**PARISH OF ST HELIER**

**ROADS COMMITTEE MEETING**

**Wednesday 20 November 2024 at 9.30am**

**A G E N D A**

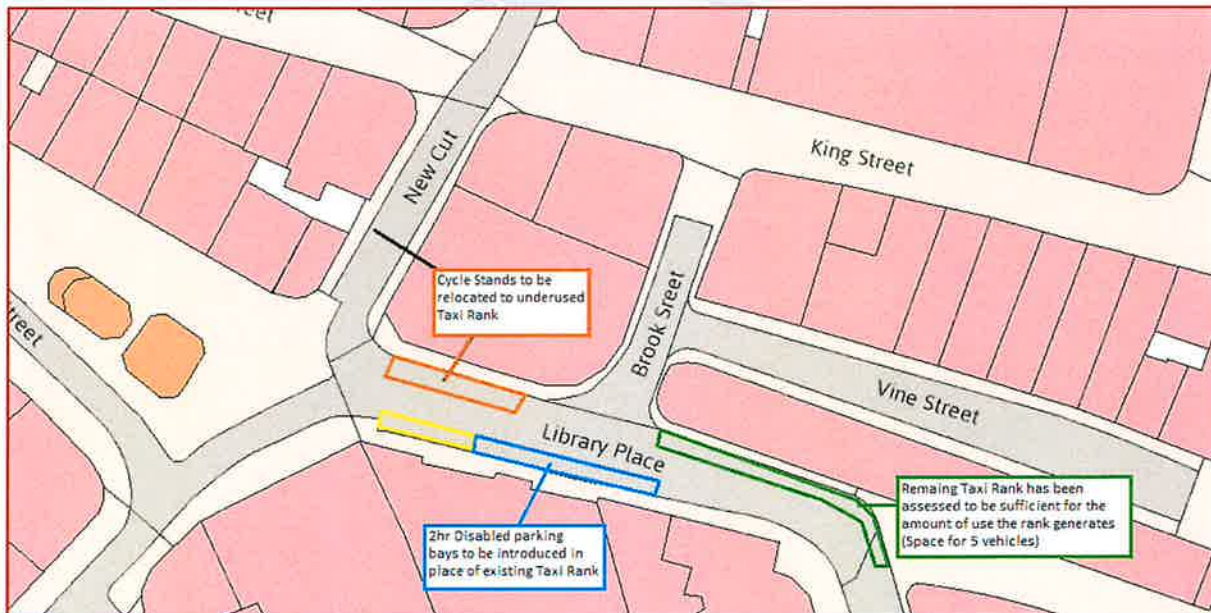
The Minister for Infrastructure and the Assistant Minister have requested that the following changes be brought forward in Library Place. The Ministers wish to provide better access to cycle parking and remove existing cycle provisions from New Cut to provide better access for pedestrians and cycles into the town centre.

The Ministers want to introduce more disabled parking into the area to provide more benefits to disabled drivers. The I&E Team has assessed the usage of the taxi ranks in Library Place and established the ranks are over-provided.

As a result of I&E's recent assessments, they have determined that there is a need only to provide enough space for a small number of Stationary taxis on the rank. As such, the existing bay marked in green on the sketch below will be the only rank that remains.

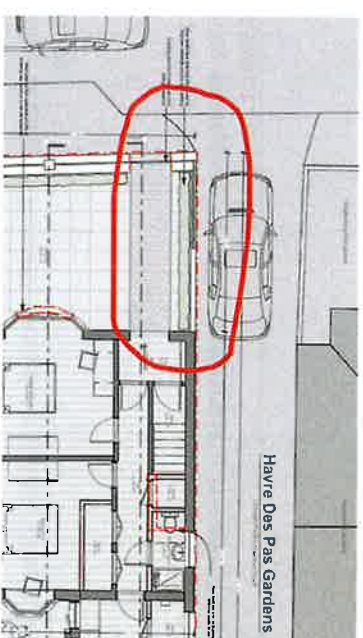
4. The garden wall and planting adjacent the entrance path to the property on the northern end, as circled on the plan on the right-hand side, must be kept low in perpetuity and must be conditioned on any approval as set out in '**Access onto the Highway – Standards and Guidance**' as produced by Government of Jersey's Infrastructure and Environment Department, available online at:  
<https://www.gov.je/travel/roads/pages/roadhousingdevelopment.aspx>. Everything in the visibility areas so formed, including gates, pillars, walls and plants growth, to be permanently restricted in height to 900mm above road level in perpetuity. This is essential to ensure that motorists have clear visibility at the junction of the road as they pull out of Havre des Pas Gardens onto Green Street.
